5.1. MATERIAL CHANGE OF USE FOR DWELLING HOUSE AT LOT 7 STEWART CREEK ROAD- REFUSAL

REPORT AUTHOR(S)	Daniel Lamond, Planning Officer
GENERAL MANAGER	Michael Kriedemann, Acting General Manager Operations
DEPARTMENT	Development Assessment and Coordination
PROPOSAL	Dwelling House
APPLICANT	Joe Berthelson C/- Brazier Motti Pty Ltd PO Box 1185 CAIRNS QLD 4870
LOCATION OF SITE	Stewart Creek Road STEWART CREEK VALLEY
PROPERTY	Lot 7 on RP741831

1. Attachment 1- Proposal Plans **[5.1.1]**

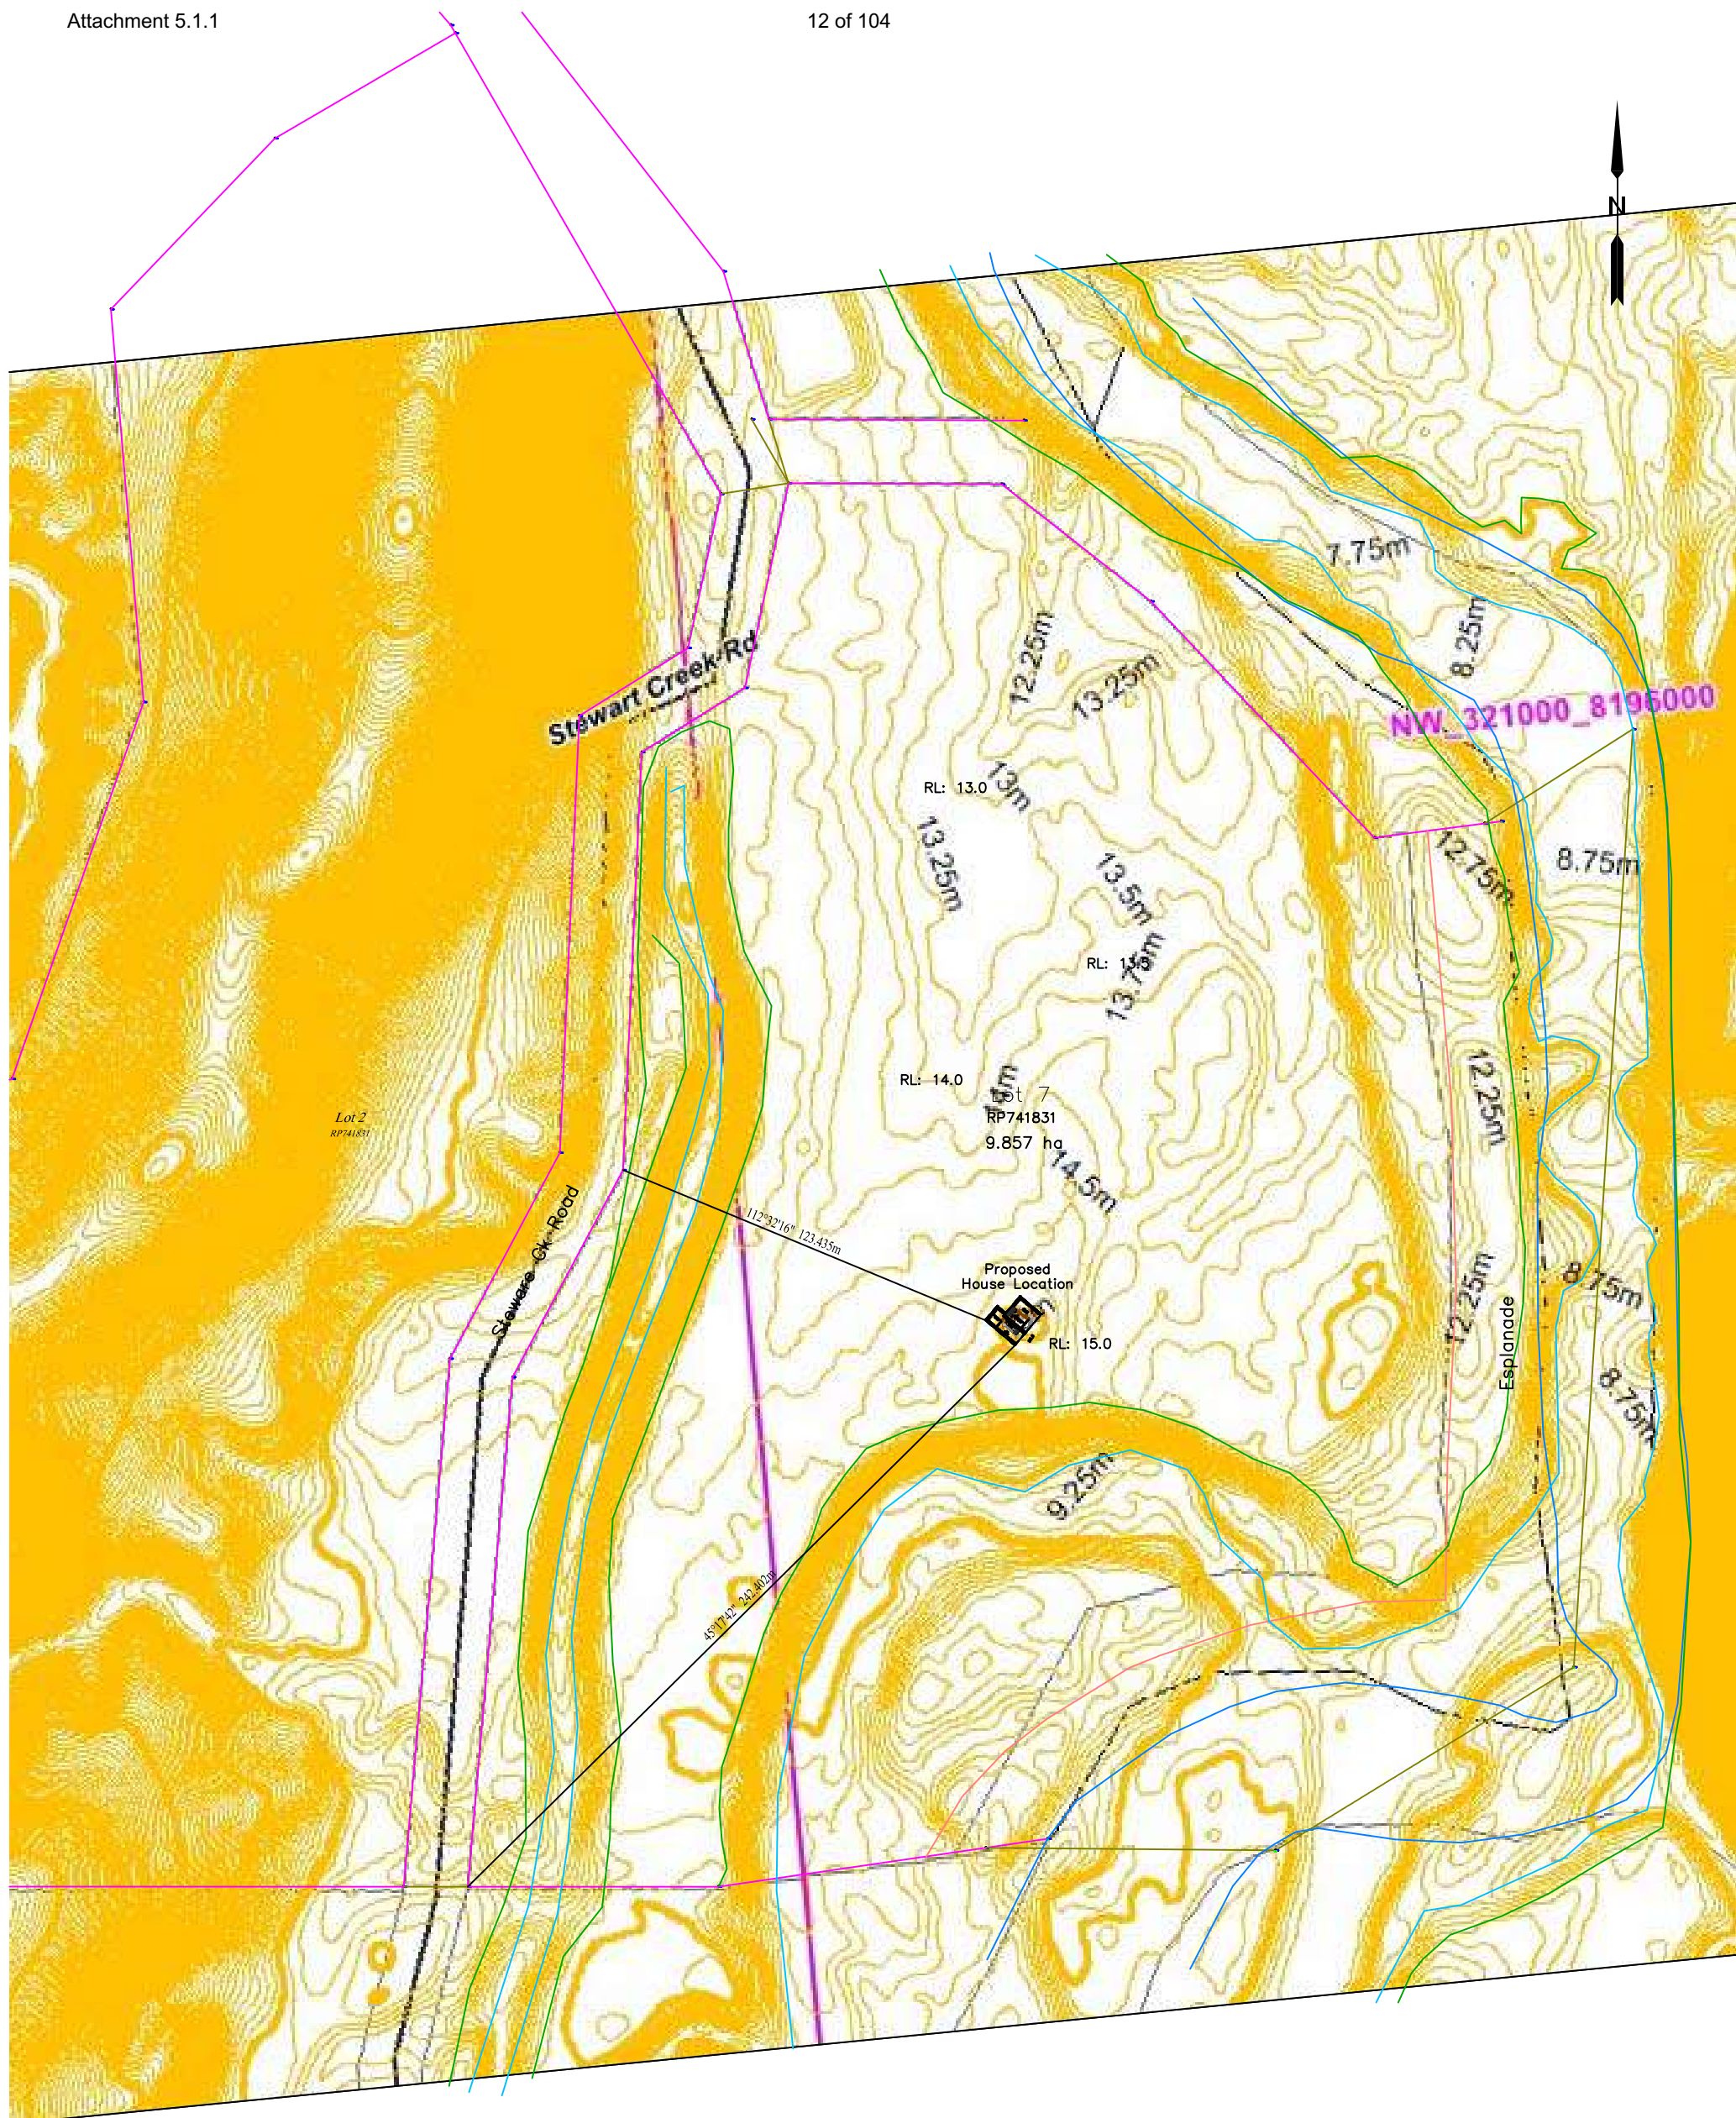
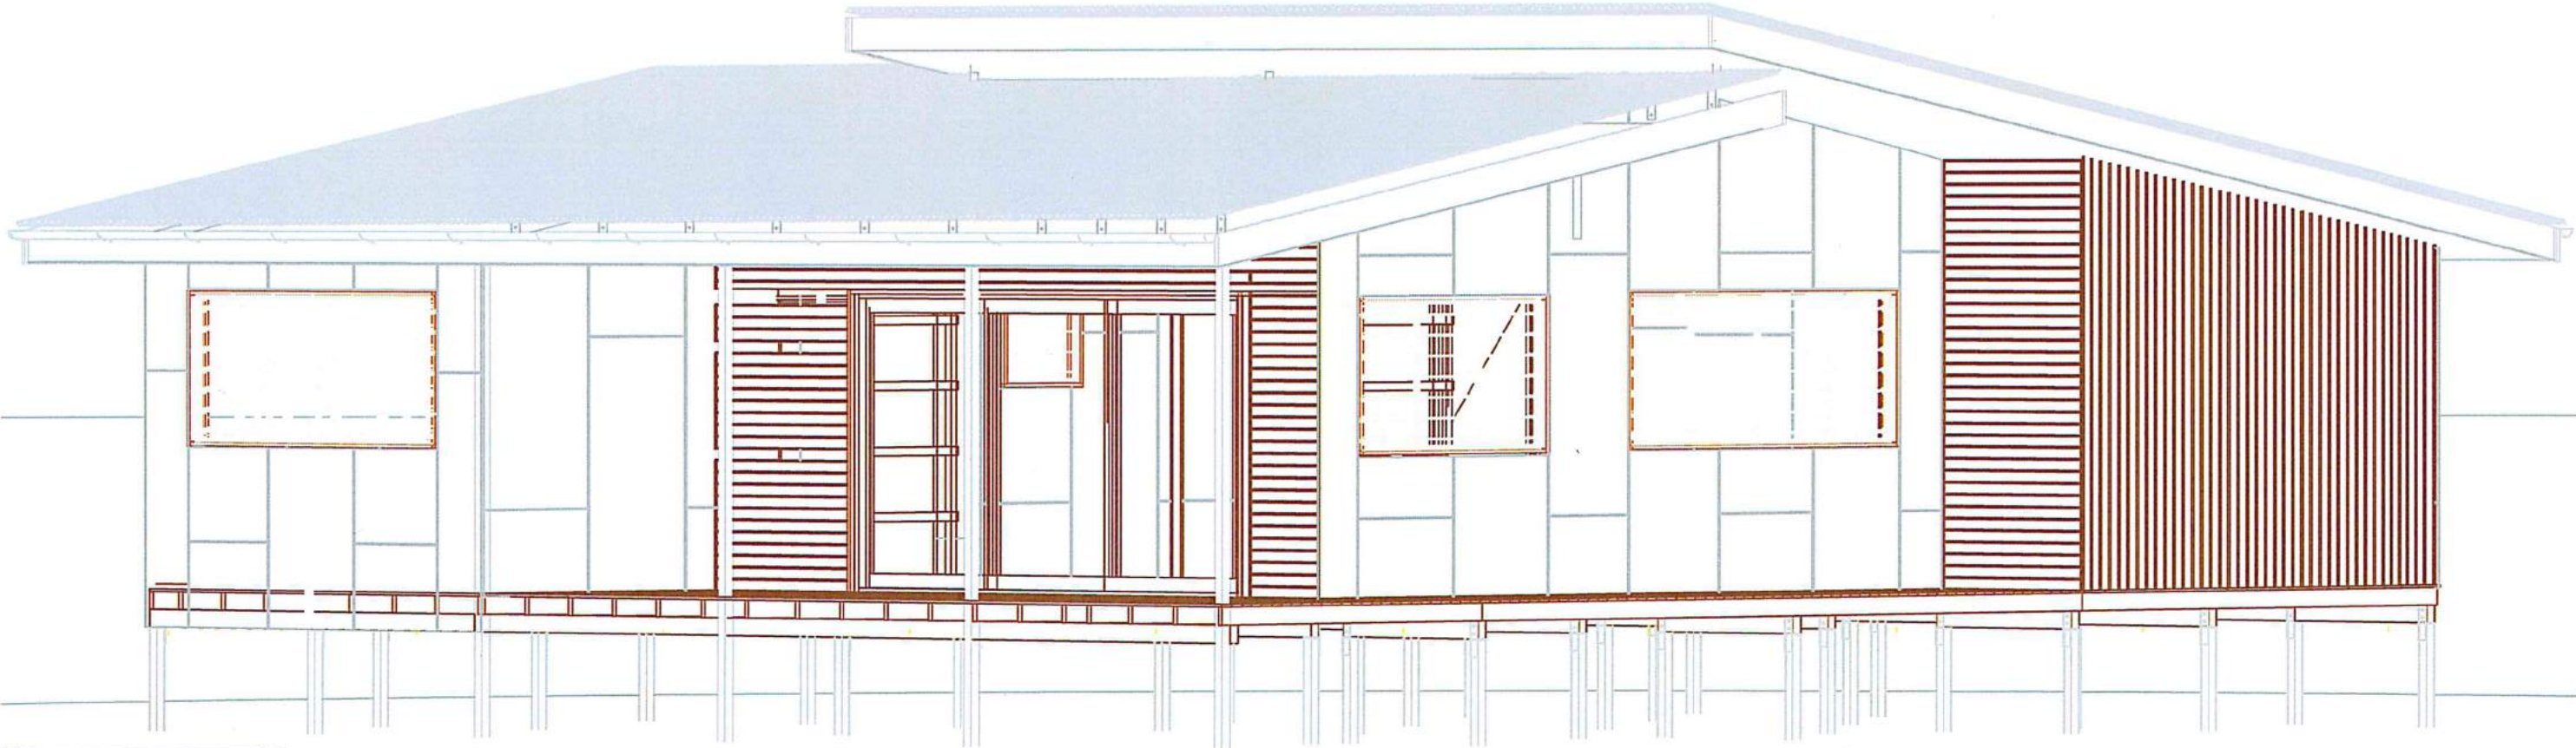
Proposed is a code assessable material change of use development application for a dwelling house at vacant lot 7 on RP741831. The house is proposed to be sited on a raised mounded area and consists of a raised stump footing design. The house proposed is single storey and complies with the benchmarks set by the relevant development codes of the 2018 Douglas Shire Planning Scheme with the exception of the Flood and Storm Tide Hazard Overlay Code. Attachment 1 shows the site layout as proposed.

The proposal includes design features which attempt to mitigate flood water inundation. This is by way of mounding a building pad and siting the floor of the house on one metre high stump footings on top of the mounded pad. However, without a flood study to give a flood height level, the solution proposed has no benchmark to base these heights from. Information has been provided from residents who have lived in the surrounding area for a number of decades to the affect that to their knowledge, the site has not been inundated by Stewart Creek in an event. However, immunity from flood waters for dwelling houses must be given for the 1 in 100 year probability (1%) for a flood as per *Table 8.2.4.3.b Minimum Immunity (floor levels) for development* from the Flood and Storm Tide Hazard Overlay Code of the Planning Scheme.
